SERVICE BULLETIN DSPbR-025

Product: DSPbR Rebroadcast Repeater

Subject: Firmware 5.4.0 Release Date: 23rd February 2019

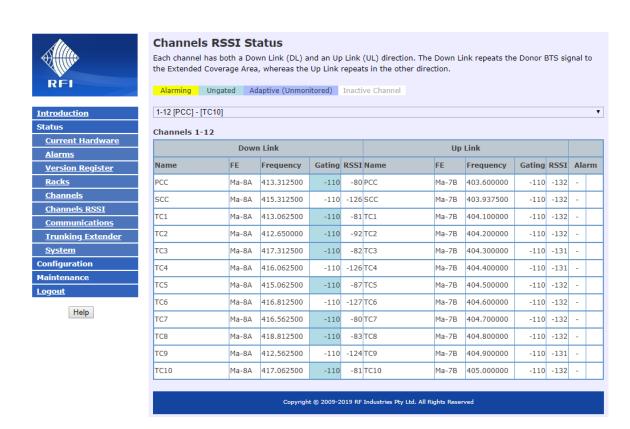
i) Trunking Extender (T-Ex).

The Trunking Extender (T-Ex) is a patented DSPbR option that provides an innovative solution for the rebroadcasting of P25 Phase 1 and Phase 2 networks in tunnel, in-building and outdoor coverage enhancement applications.

The Trunking Extender transcodes the rebroadcast P25 network donor site's Control Channel. The DSPbR-provided coverage footprint is frequency-translated to a different set of frequencies to those of the donor network site, and the transcoded Control Channel data content passing through the DSPbR makes subscriber terminals see the DSPbR as 'another' network site.

The Trunking Extender functionality requires a Trunking Extender Daughter Card to be fitted to Side A of the DSP module (refer section 4.3.5 of the DSPbR User's Manual). This card is an option that must be purchased to have the Trunking Extender functionality available for use in a DSPbR. When this optional card is fitted, it is automatically detected by the DSPbR and Trunking Extender menu items and selections will appear in the DSPbR webserver GUI.
